Re: BusConnects Lucan to City Centre Core Bus Corridor Scheme
Lucan to Dublin City Centre

Here is the South Dublin County Council submission on the current Lucan to City Centre Core Bus Corridor SID Planning Application. Please acknowledge receipt of our submission by email.

Please note that on the attached GA drawing sheets there are notes (Yellow boxes) added and here is a summary of those notes in the Table below:

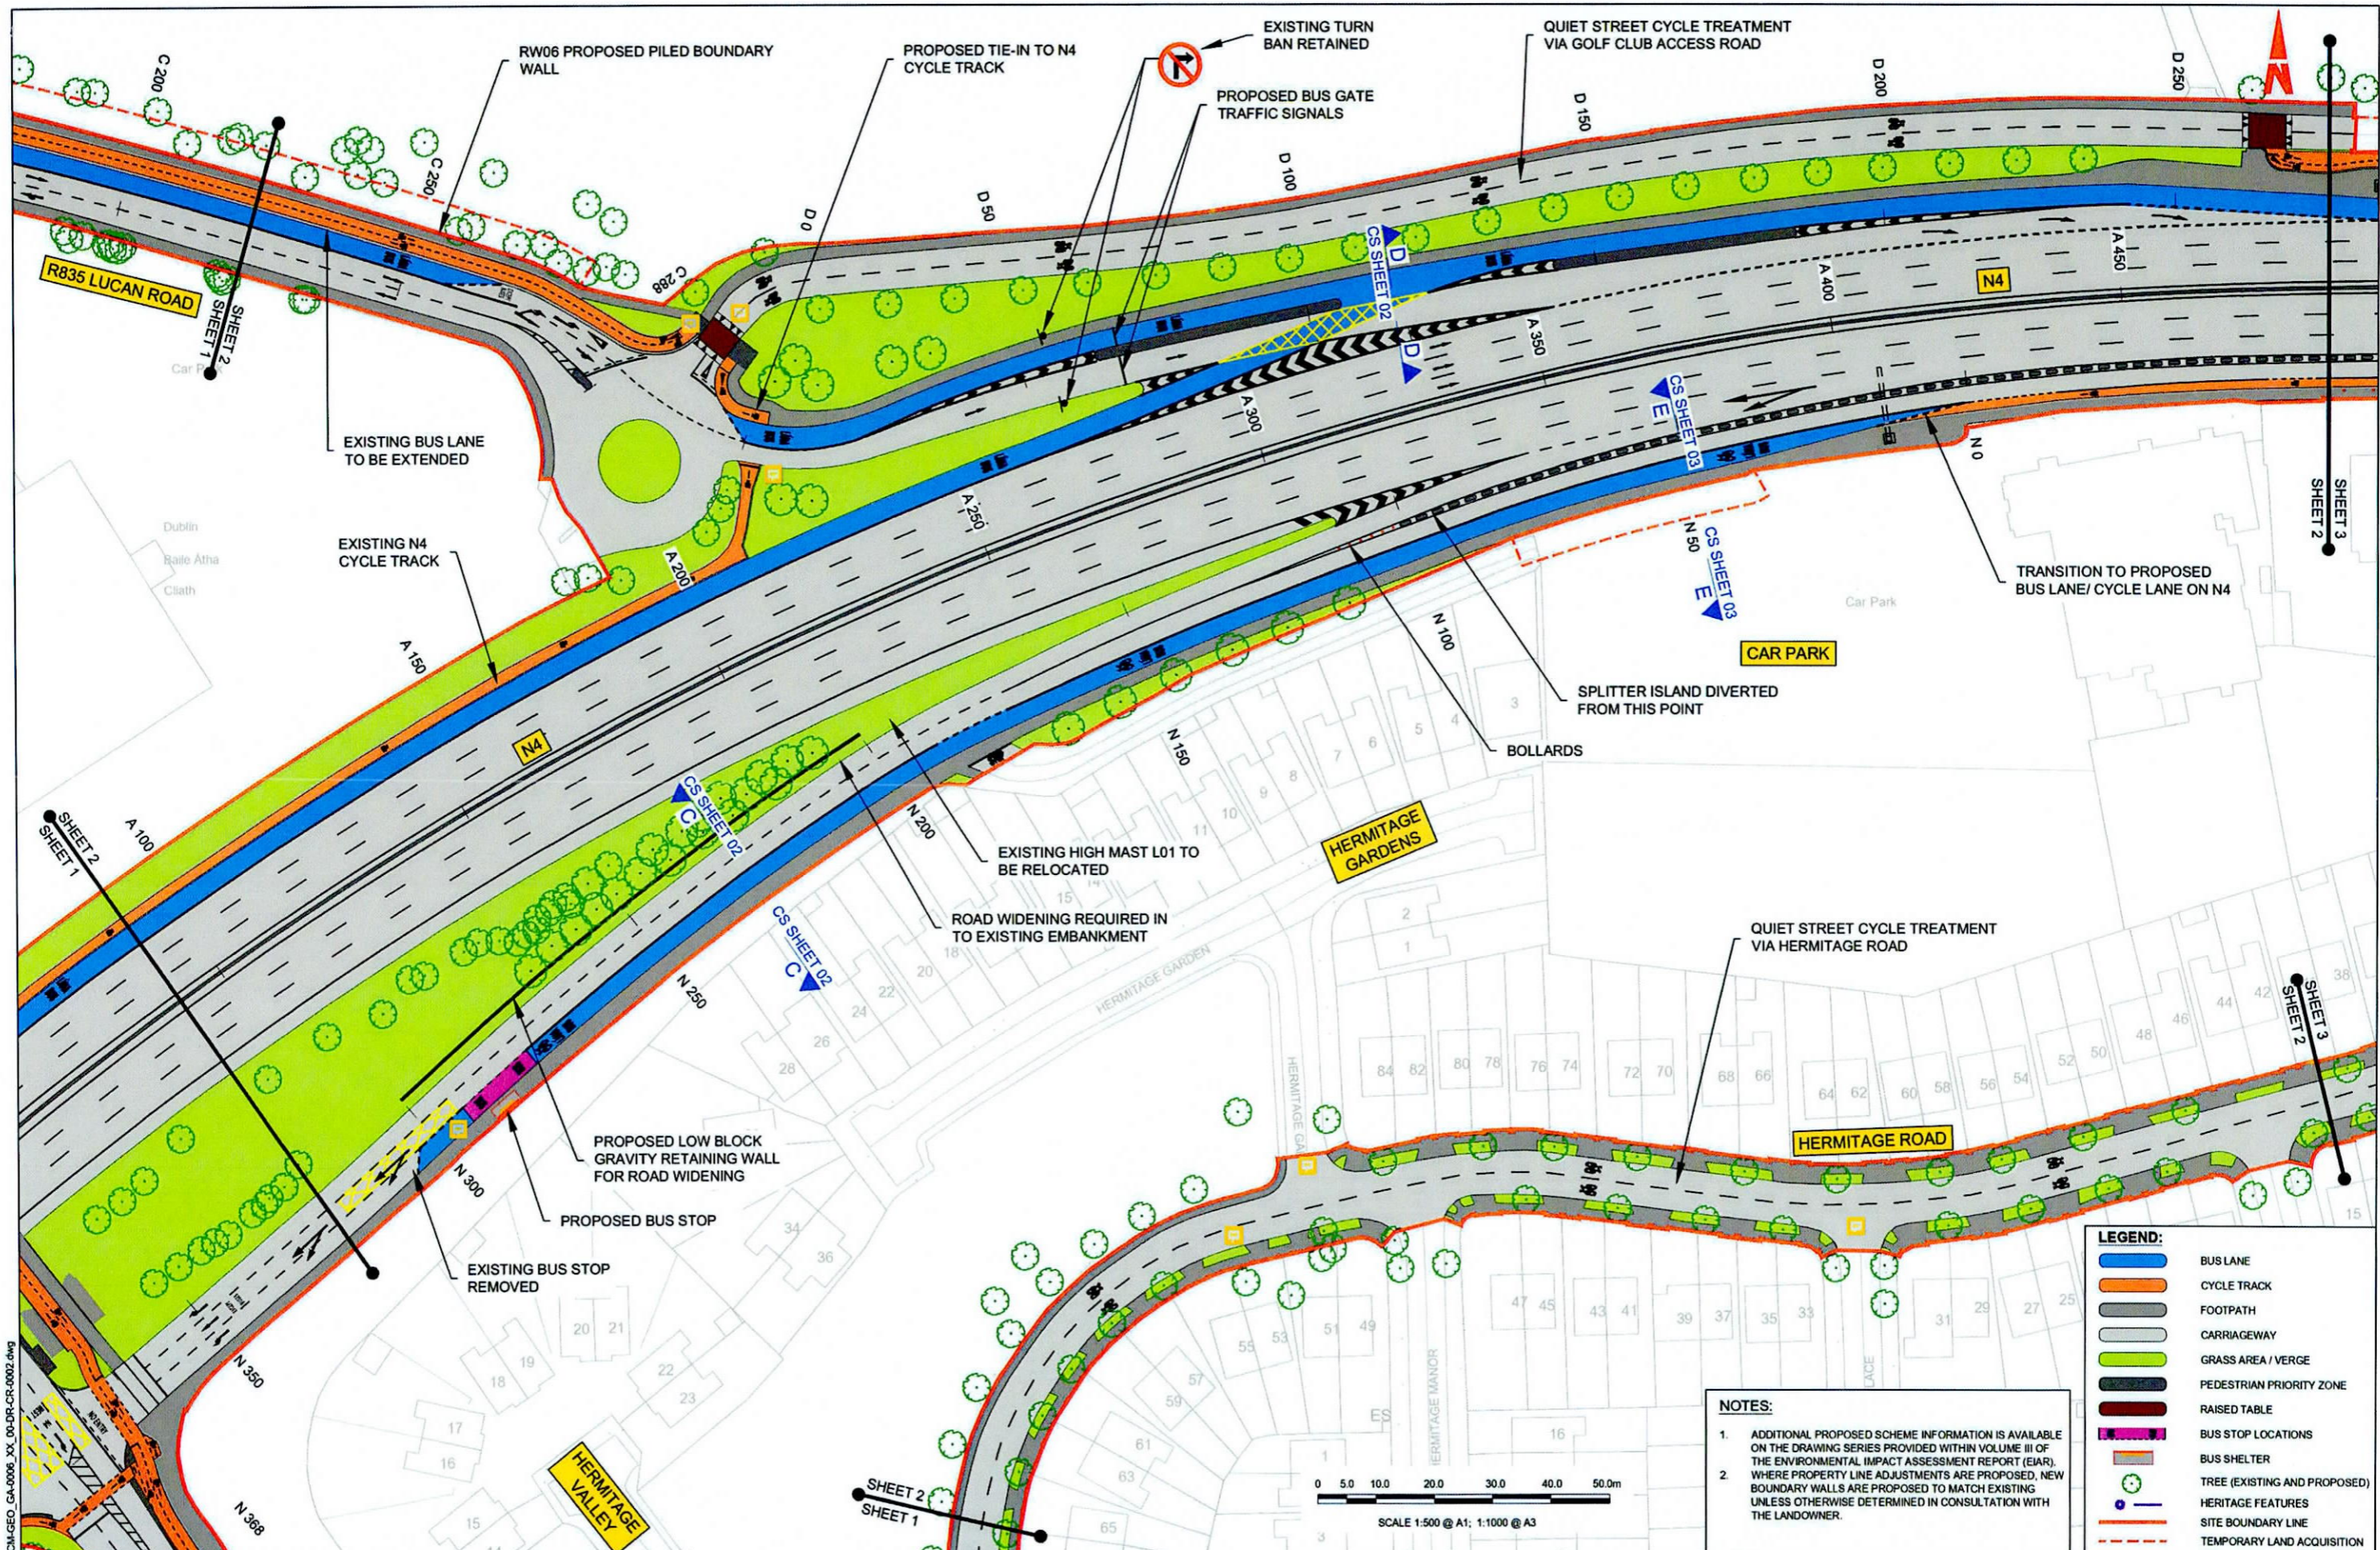
Comment Number	Sheet Number	Chainage	Location	Comment
AT 01	Sheet 01	CH B 0	Junction of westbound N4 off ramp and R136	Same note re: left to go right across cycletrack
AT 02	Sheet 01	CH C 200	General note re: two-way cycle tracks	For two-way cycle track, NCM recommends the lane going with the traffic is closest to the carriageway
AT 03	Sheet 01	CH B 50	New ped/cyclist bridge	Why is S/B lane narrower than N/B?
AT 04	Sheet 01	CH B 50	Junction of eastbound N4 off ramp and R136	How does a cyclist at this location join the N/B or S/B cycle track?
AT 05	Sheet 01	CH B 150	Along R136	Could a planted verge / SUDS feature be used here?
AT 06	Sheet 01	CH B 250	Junction of R136 and Lucan Road	Is a left to go right needed at this location? Would a straight through bypass/pass on left and a right turn ghost island be more appropriate. In current arrangement, right turning cyclist needs to cross N/B & S/B cyclists. Does approach for left to go right across traffic lanes need to be applied to crossing cycle tracks? Or better again, a widened S/B cycle track with no turning marks.

AT 07	Sheet 01	CH B 250	General note re: two-way cycle tracks	For two-way cycle track, NCM recommends the lane going with the traffic is closest to the carriageway
AT 08	Sheet 01	CH B 250	Junction of R136 and Lucan Road	As this is a signal controlled junction, can the bend in the cycle track crossing be removed. Is there a stop line on the island? Is this proposed as a two-stage crossing? There would appear to be limited stacking for cyclists on the island.

AT 09	Sheet 01		Hermitage Road (inset)	Junction radius should be tightened.
AT 10	Sheet 01	CH B 250	Junction of R136 and Lucan Road (west side)	The crossing point for pedestrians is not on either desire line esp. to/from the south and will likely not be used.
AT 11	Sheet 01		Junction of Hermitage Road and R136	For cyclists coming from Hermitage Road wanting to join the N/B two-way, is the design intent that the mount the ramp and join the shared area? Will this be intuitive to cyclists and drivers? Is road sufficiently narrowed to encourage turning cyclists to "hold the lane" and prevent drivers "squeezing past" cyclists waiting to turn?
AT 12	Sheet 01	CH B 150	Junction of Hermitage Road and R136	Should an additional protection island be installed at this location Due to bend in road crossing, likely that cyclists headed for Hermitage Road will continue straight in layout shown.
AT 13	Sheet 01	CH B 150	Junction of Hermitage Road and R136	Is local widening needed at this location to allow all cycles to make 90deg corner?

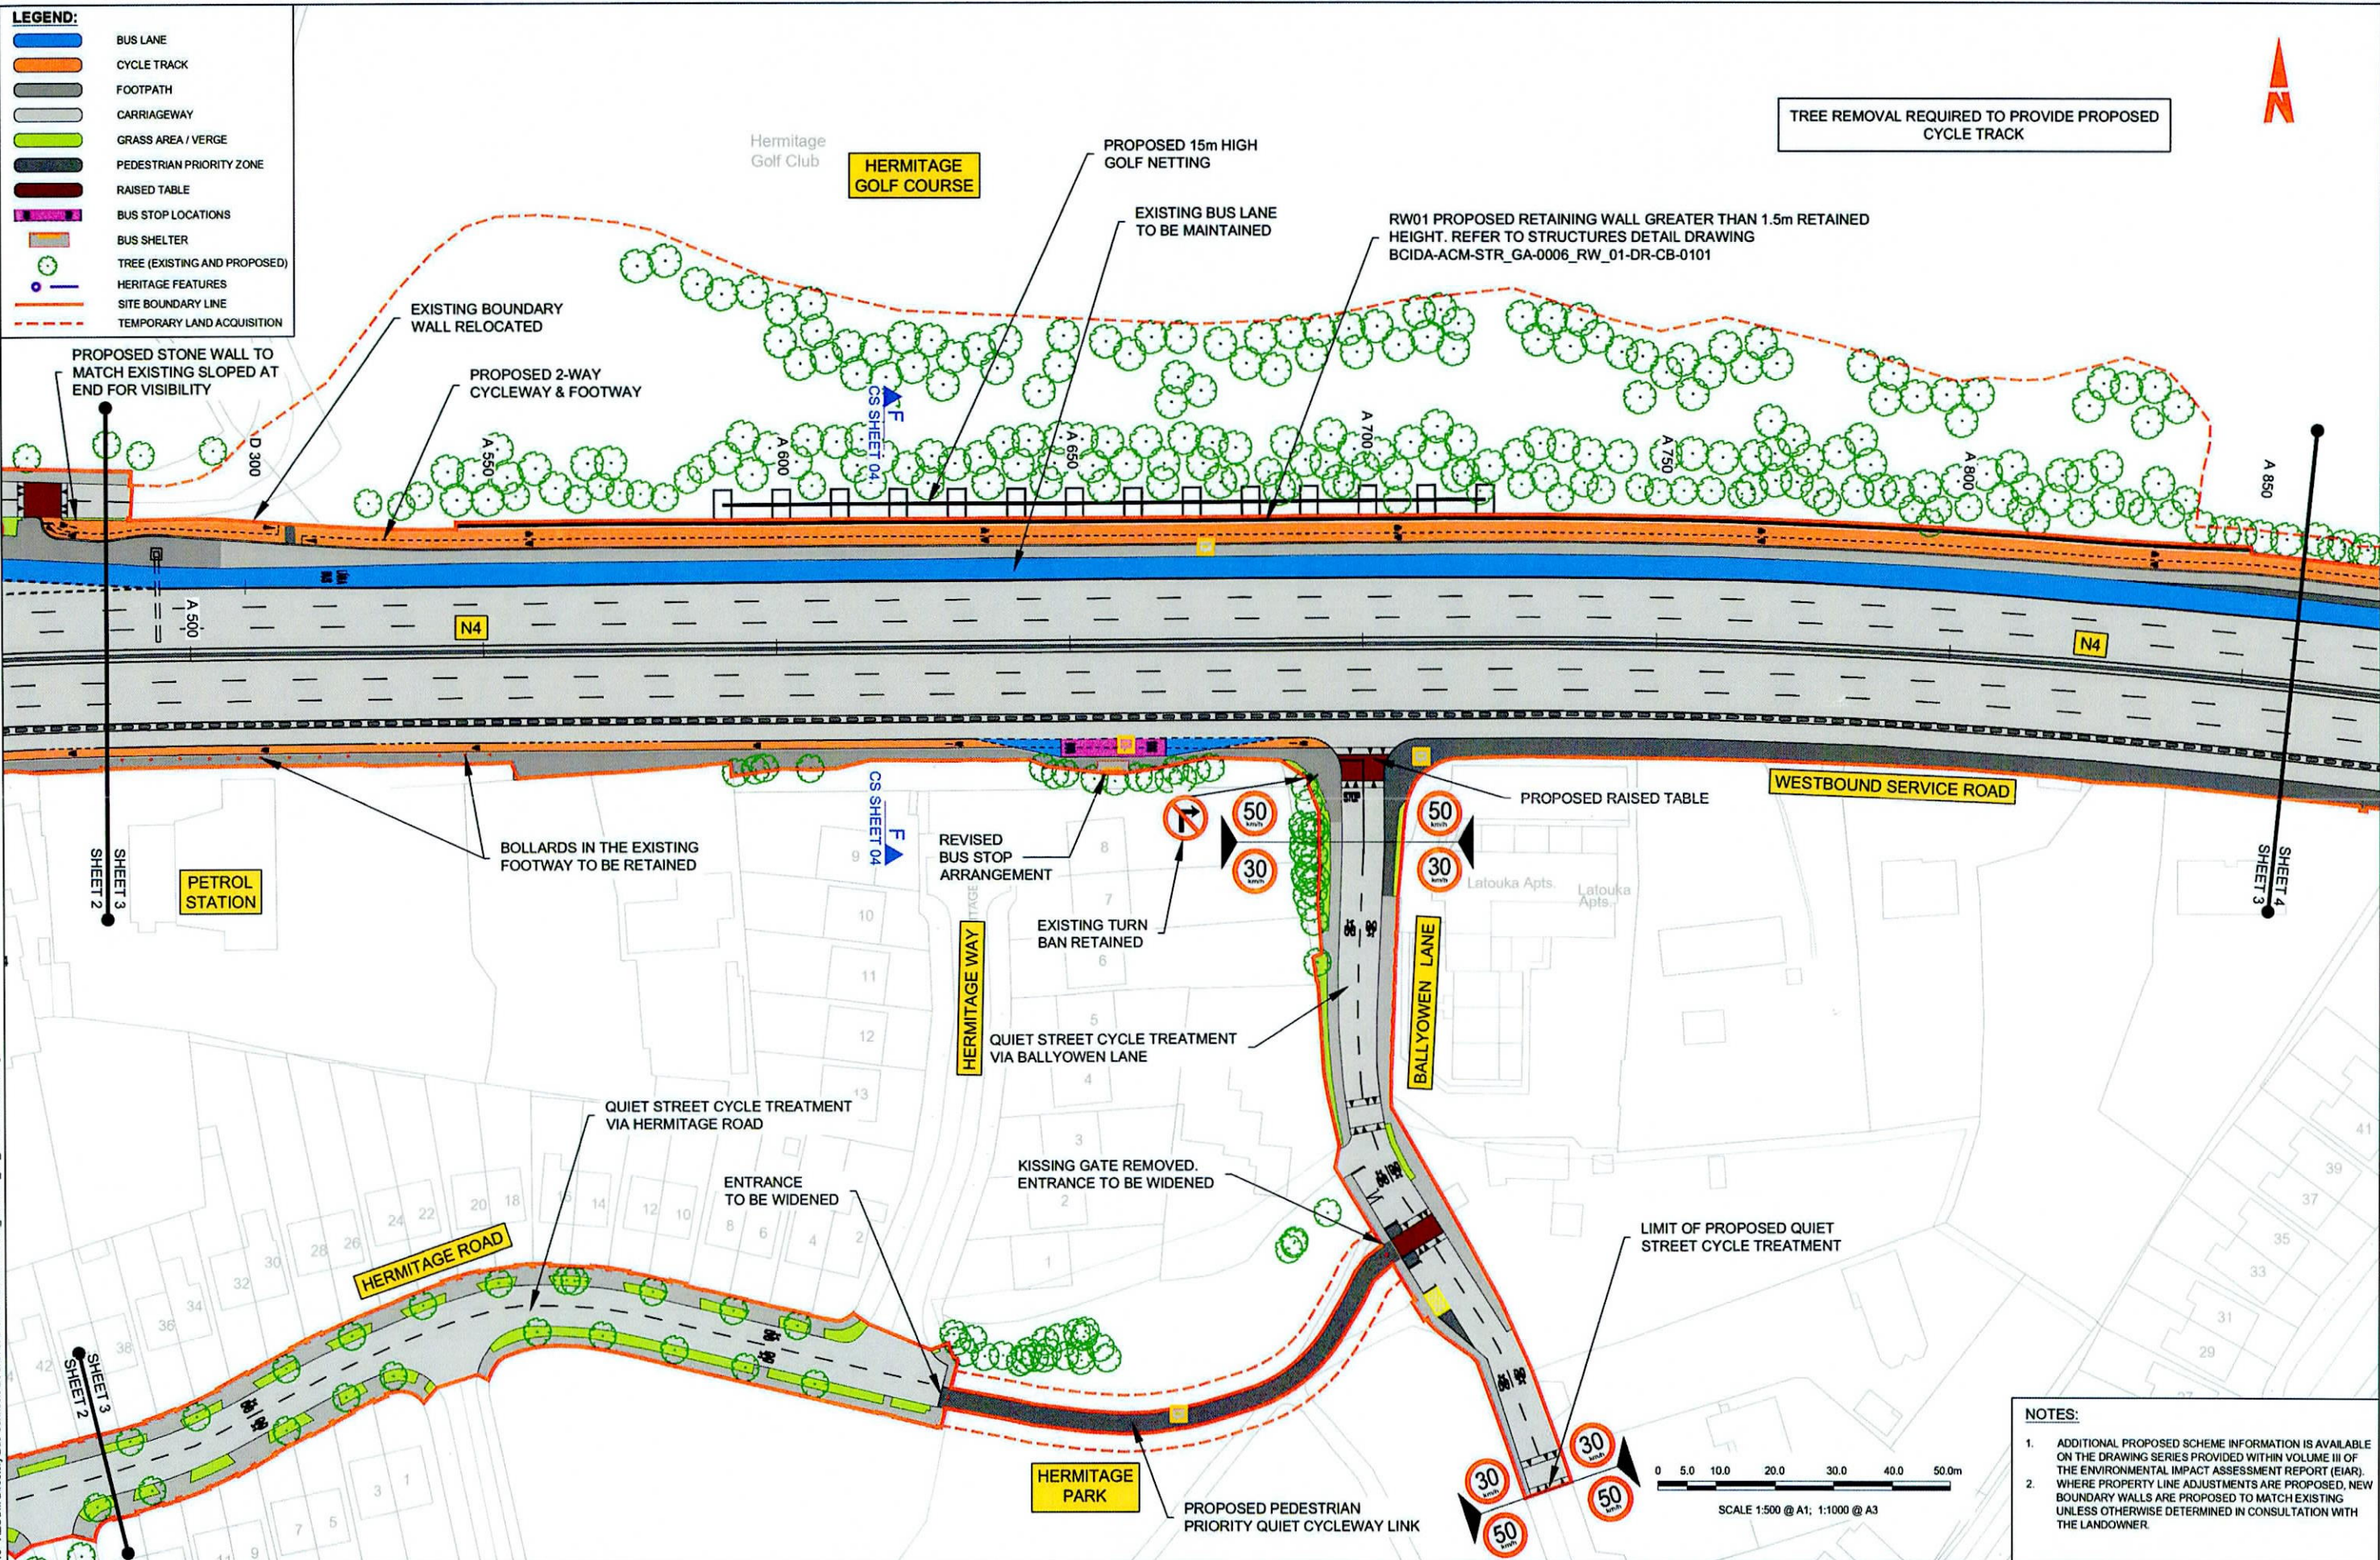
AT 14	Sheet 02	CH C 268	Junction of golf course road and roundabout	Same note re: cyclists turning off quiet street using ramp
AT 15	Sheet 02	CH C 268	Junction of golf course road and roundabout	Should shared area/footpath be widened at this location as there is a high number of potential conflicts/movements.
AT 16	Sheet 02	CH C 268	Junction of N4 on ramp and roundabout	Can a direct alignment be provided here to avoid an unnecessary 90 deg turn
AT 17	Sheet 02		Hermitage Road	Is existing width to be narrowed? Is the existing sufficiently narrow to work as a quiet street?
AT 18	Sheet 02	CH N 300	Westbound N4 off ramp towards R136	How will cyclists using the bus / cycle lane join the N/B & S/B cycle track?
AT 19	Sheet 02		Hermitage Road	Junction radii

AT 20	Sheet 02		Hermitage Road	Junction tightening
AT 21	Sheet 03	CH A 650	N4	Assume it is anticipated that cyclist numbers will be >>> pedestrian numbers along this section and there benefit of footpath as a buffer for the cycle track outweigh concerns about peds between traffic lane and cycle track.
AT 22	Sheet 03	CH A 650	Bus stop on N4 westbound service road	Would an inline bus stop and bus stop bypass be a better solution at this location.
AT 23	Sheet 03	CH A 700	Junction of westbound N4 service road and Ballyowen Lane	How does a cyclist get from the shared path to the cycle track? As design stands, cyclist needs to: leave ped priority zone, cross an side road; join a cycle track (possibly by joining the side road and then joining the main road); leave a cycle track after c. 10 m; cross a bus stop and join a cycle track. Within approx 80 m.
AT 24	Sheet 03		Hermitage Park	What width is this shared path?
